CREEKSIDE AT LORSON RANCH FILING NO. 1

PUD Development & Preliminary Plan

PCD FILE NO.: PUDSP-18-5

COVER SHEET

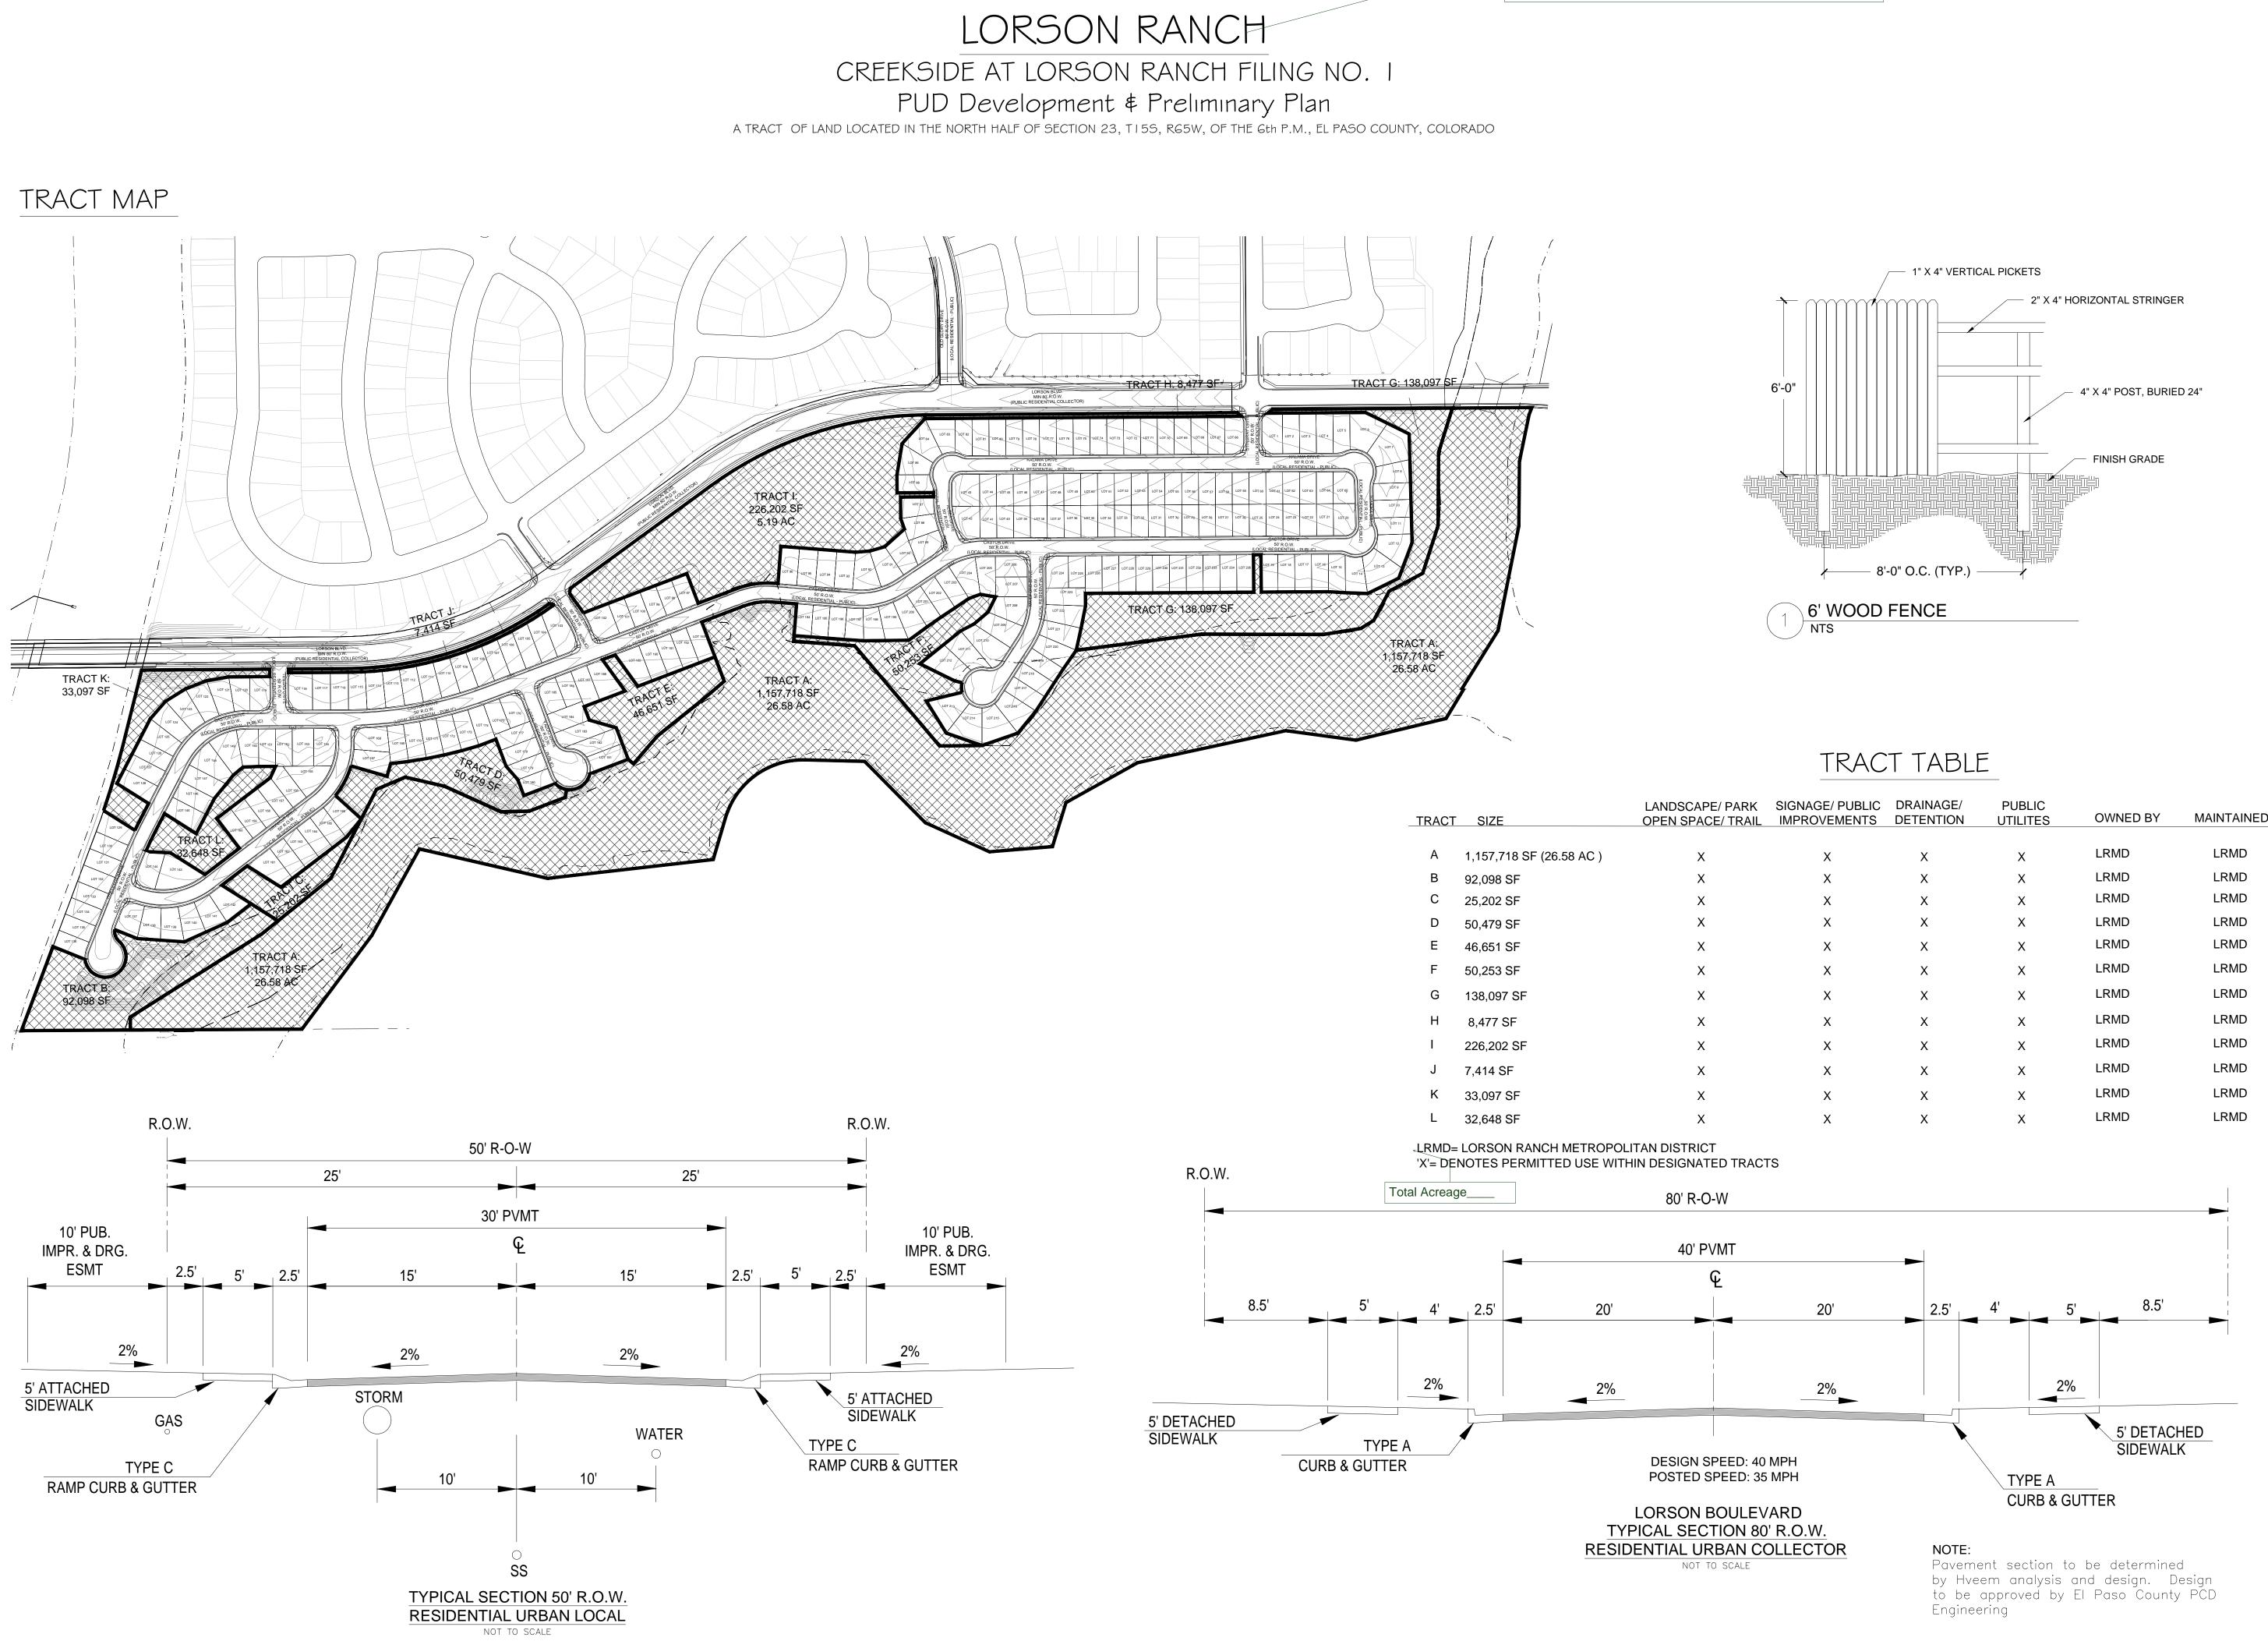
- 8. Minimum Width of Lot at Front Building Setback Line: Thirty Five Feet (35') or as otherwise shown. 9. Setback Requirements: a. Front yard: Twenty Feet (20') to Face of Garage Do you want to include these? Fifteen Feet (15) to Face of House $_{\Box}$

- b. Side yard: Five Feet (5') Home office (max SF), day care up to X kids, d. Corner yard (Non-Driveway Side): Ten Feet (10) Internet business? Limit to number of employees allowed to come to house?

- occupation per the LDC as amended

Add: Grass Buffer BMPs will be maintained in accordance with a Permanent BMP Agreement and Easement and O&M Manual to be recorded at the time of final plat.

- B643P? per PPRBD

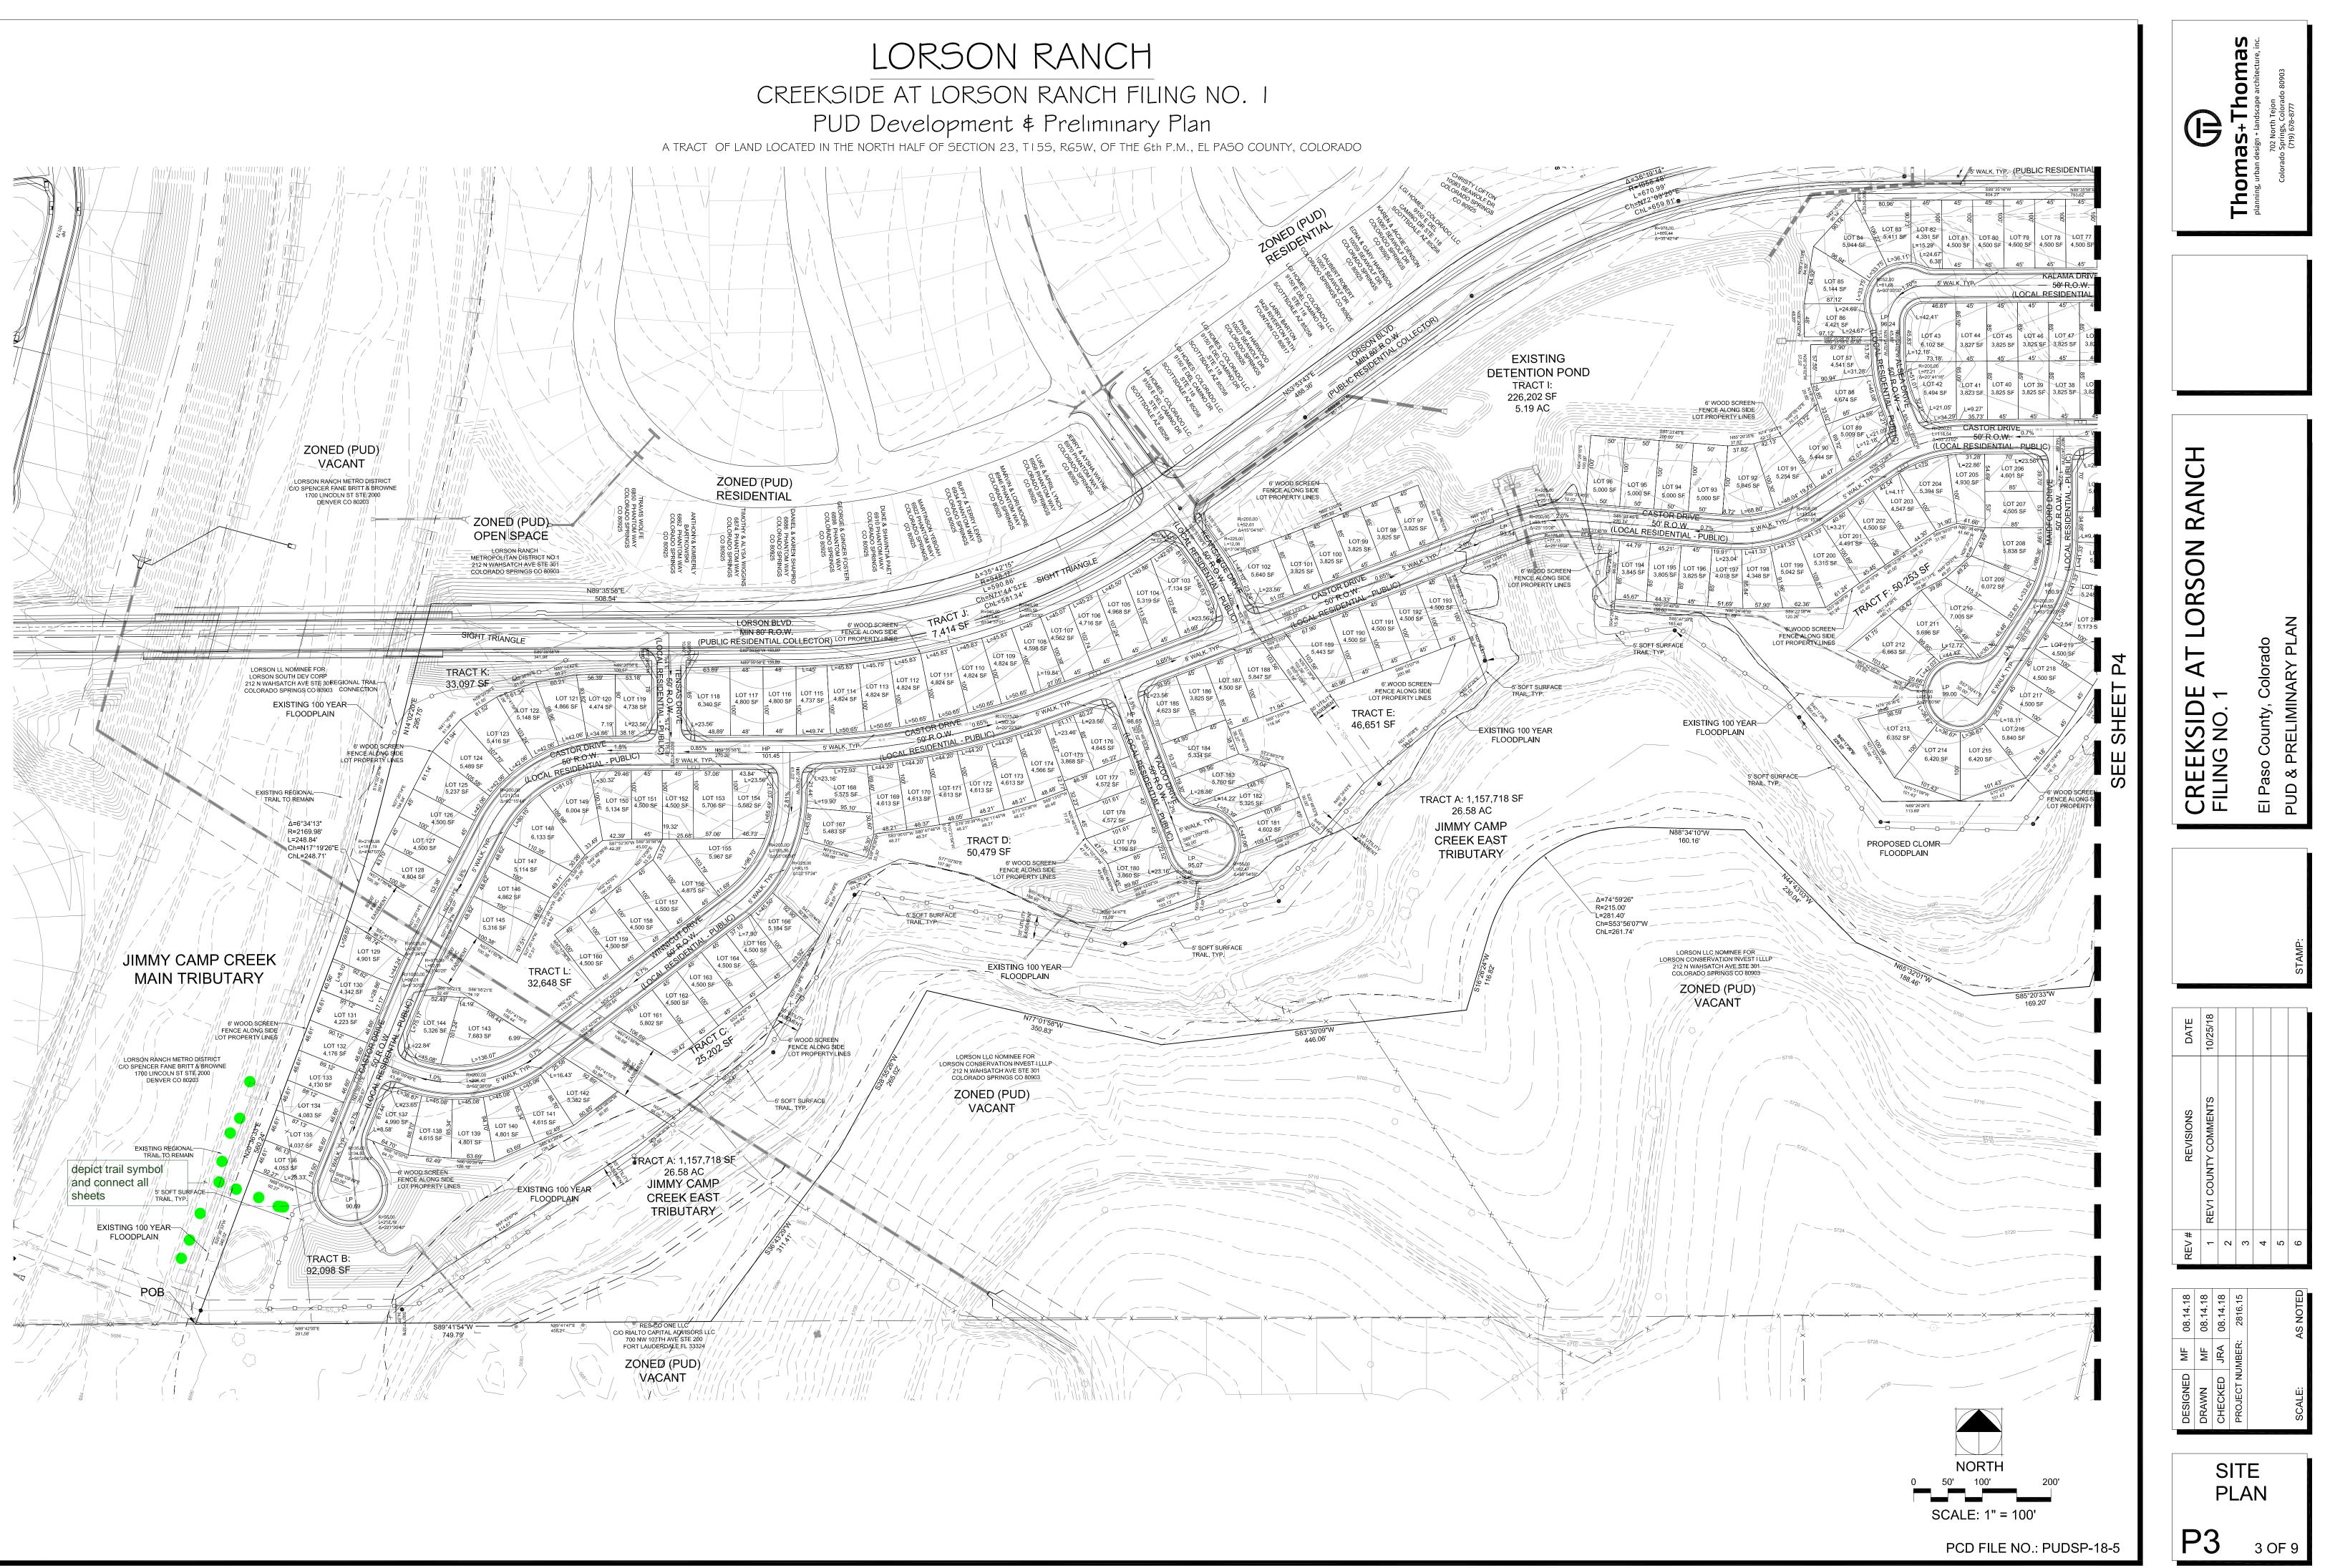
Subject: Callout Page Label: 2 Author: dsdparsons Date: 11/19/2018 11:59:23 AM Color:	Delete On all pages The title is Creekside at Lorson Ranch Fil 1 [and 2 (If LOMR lots are to be platted at a later date; if not you can submit 1 plat but not record any of it until the LOMR is 100% completed.]
depty frain without a second s	Subject: Callout Page Label: 3 Author: dsdparsons Date: 11/19/2018 4:30:13 PM Color:	depict trail symbol and connect all sheets
